Wells below forestry ditches: Why not considered?

UPPER FLORIDAN
RECHARGE PROJECT

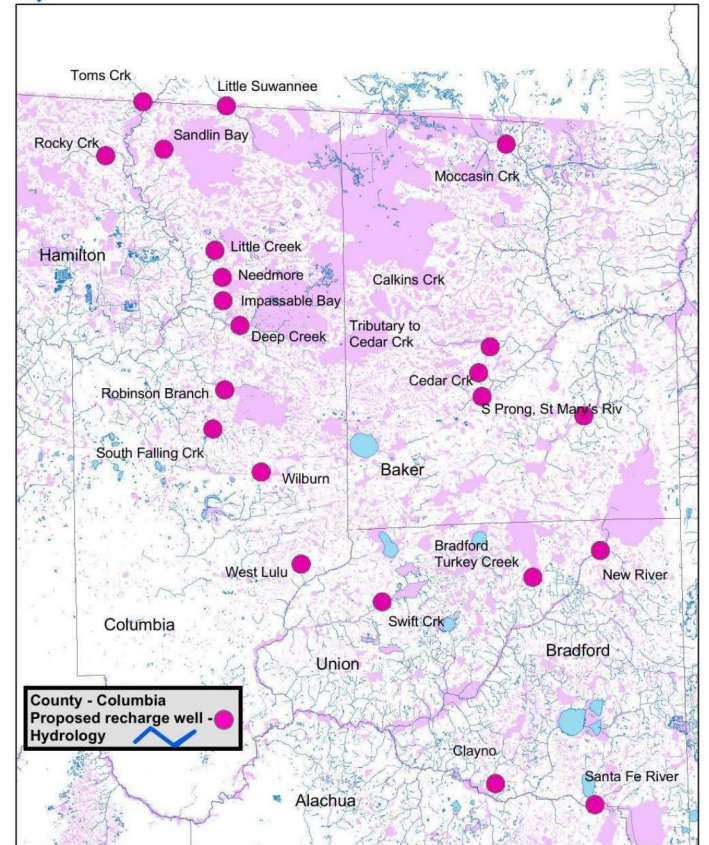
- Dennis J. Price, P.G. proposed in 2016
- They're at overflow of wetlands below such ditches
- Similar to WFNF wetlands
- How can treated wastewater be cleaner than rainwater?
